**Economic and Social Council**Distr.: General
19 July 2012

Economic Commission for Europe**Inland Transport Committee****World Forum for Harmonization of Vehicle Regulations****Working Party on General Safety Provisions****103rd session**

Regulation No. 107 (M₂ and M₃ vehicles) – Proposals for further amendments**Proposal for the 06 series of amendments to Regulation
No. 107 (M₂ and M₃ vehicles)****Submitted by the expert from the European Commission***

"Figure 23 C

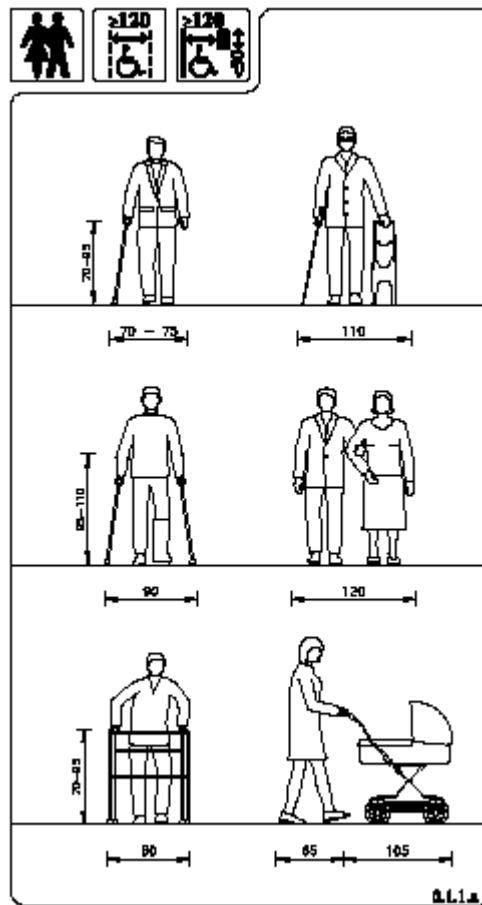
Annex 4, insert a new figure 23 C, to read:

Pictogram for pram and pushchair area

Colour: blue basis with white symbol

Size: at least 150 x 100 mm"
